Project	IEEE 802.16 Broadband Wireless Access Working Group < http://ieee802.org/16 >	
Title	QoS Control Scheme for data forwarding in 802.16j	
Date Submitted	2007-05-5	
Source(s)	<p>Hang Zhang, Peiyong Zhu, Mo-Han Fong, Wen Tong, David Steer, Gamini Senarath, Derek Yu, Mark Naden, G.Q. Wang</p> <p>Nortel 3500 Carling Avenue Ottawa, Ontario K2H 8E9</p> <p>Ranga Reddy US Army - CERDEC, USA</p> <p>D. J. Shyy MITRE, USA</p> <p>Arnaud Tonnerre THALES COMMUNICATIONS, FRANCE</p> <p>Djamal-Eddine Meddour FRANCE TELECOM, FRANCE</p> <p>Jeffrey Z. Tao, Koon Hoo Teo, Jinyun Zhang Mitsubishi Electric Research Lab 201 Broadway Cambridge, MA 02139 USA</p> <p>Toshiyuki Kuze Mitsubishi Electric Corp 5-1-1 Ofuna Kamakura, Kanagawa 2478501, Japan</p> <p>Aik Chindapol Jimmy Chui Hui Zeng Siemens Corporate Research Princeton, NJ, 08540, USA</p>	<p>Ranga.Reddy@us.army.mil Voice: +1 732-532-0085</p> <p>djshyy@mitre.org Voice: +1 703 983 6515</p> <p>arnaud.tonnerre@fr.thalesgroup.com Voice: +33 1 46 13 2850</p> <p>djamal.meddour@orange-ft.com</p> <p>WenTong@nortel.com</p> <p>pyzhu@nortel.com Voice: +1 613 7631315</p> <p>{tao, tea, jzhang}@merl.com Voice: 617-621-{7557,7527} Fax: 617-621-7550</p> <p>Kuze.

Figure XXX. R-MAC header format with QoS info

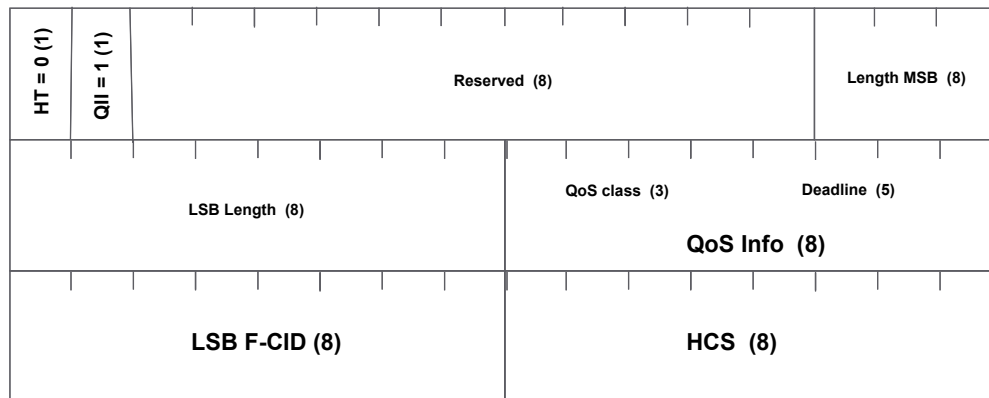
[Insert the following subclause after the end of Section 6.3.2.1]

6.3.2.1.1.1 Format of R-MAC header with QoS information

The format of R-MAC header with QoS info is shown in the following Figure XXX.
